# 1997 Corvette: Service Bulletin: Water Drips into Rear Compartment After Hatch/Glass Has Been Opened

**Number:** 73-10-55

**Models:** 1997 Chevrolet Corvette

**Figure 1 - Sideview**

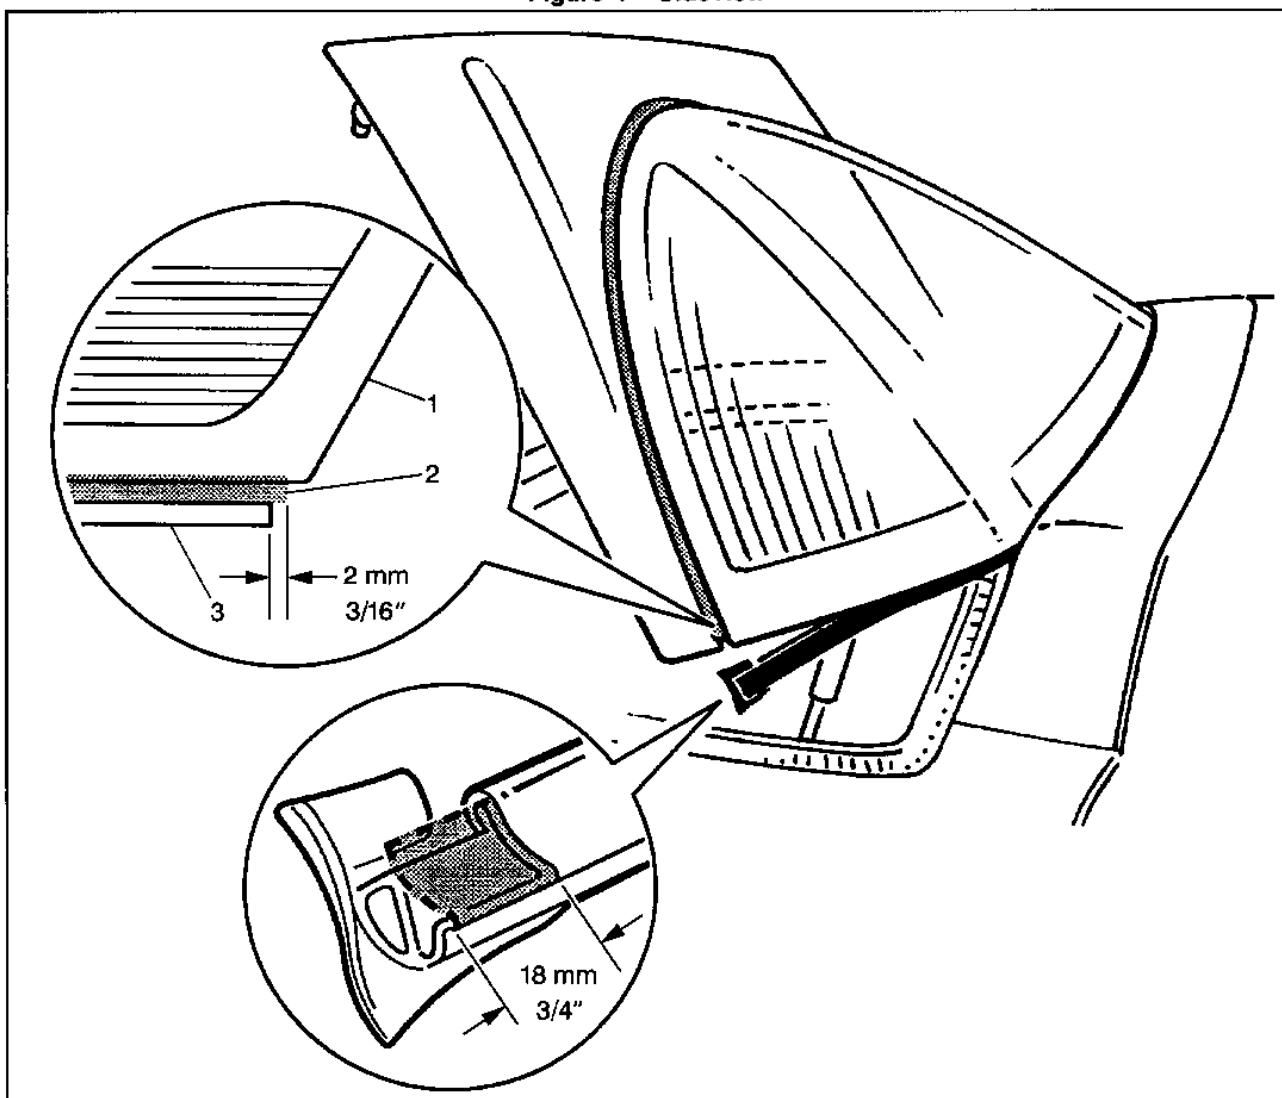
**Condition:** Some owners may comment that water drips into the rear compartment after the hatch glass has been opened.

1. Pull down weatherstrip to gain access to the end of the black close out weatherstrip (see Figure 1, top view). With a utility knife, cut the close out weatherstrip so there is a 2 MM (3/16 in.) overhang of the weatherstrip to its mounting surface (See Figure 1, top view)
2. With weatherstrip pulled down, measure 18 MM (3/4 in.) from end of weatherstrip and remove shaded area from weatherstrip (see Figure 1, bottom view). Reinstall weatherstrip on hatch.
